# Product Support Bulletin 2008-004

## Maintenance of Way ~ Work Equipment Bulletin

**SUBJECT:** Brake Light Wiring Kit – 98310007

**MACHINE MODEL(S):** SP2R Dual Rail Spike Puller

**Figure 1**  
Kit 98310007 Installation Instructions

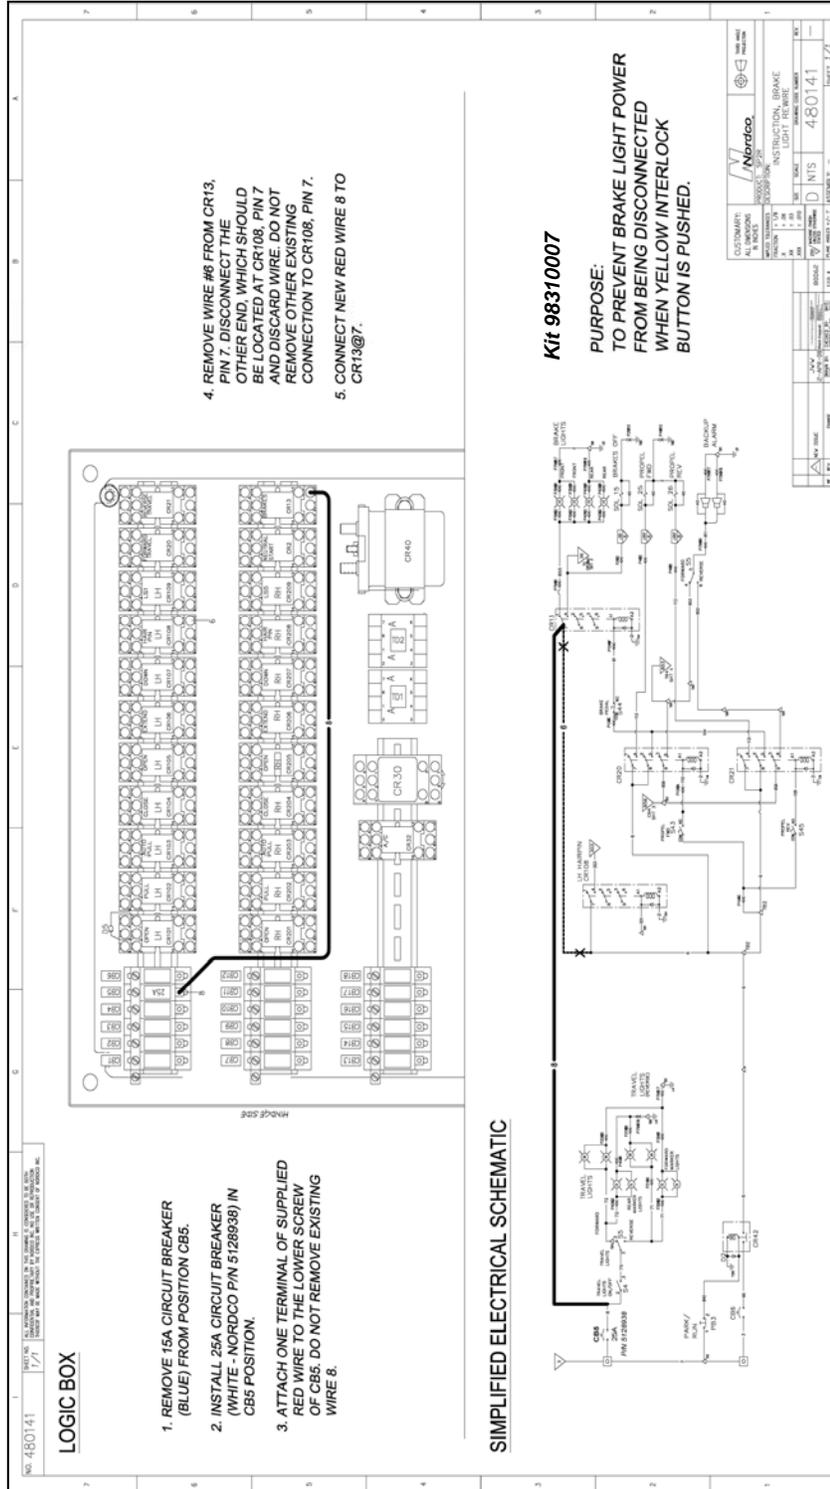
**SUMMARY:** The Brake Lights on these machines will go out when the yellow Electrical Interlock Button is pushed in. The Brake Light circuit must be rewired with Kit 98310007. **Note: This bulletin does not apply to machine serial numbers 310029, 310068-310071, 310113 and 310114. These machines have a different brake light circuit and do not need to be rewired. Also machine serial numbers 310093, 310123, 310126, 310129 and above have been corrected by Nordco.**

**OPERATIONAL IMPACT:** If the machine is stopped with the Electrical Interlock Button pushed in, the Brake Lights will not be lit and the operator of a following machine may not realize that the machine has stopped.

**ACTION:** The Brake Lights must be rewired and CB5 must be replaced with a 25 amp circuit breaker. Follow the instructions in Figure 1 on Page 2 to rewire the Brake Light circuit. After the lights are rewired, the Brake Lights should remain on with the Electrical Interlock Button pushed in. The kit consists of 1 **25 amp Circuit Breaker, p/n 5128938**, 2 feet of **Red Wire, p/n 5223092**, 2 **Ring Tongue Wire Terminals, p/n 5164299** and **installation instructions**. Installation should take approximately 30 minutes. **Be sure to follow all Lockout-Tagout procedures before installing the kit.**
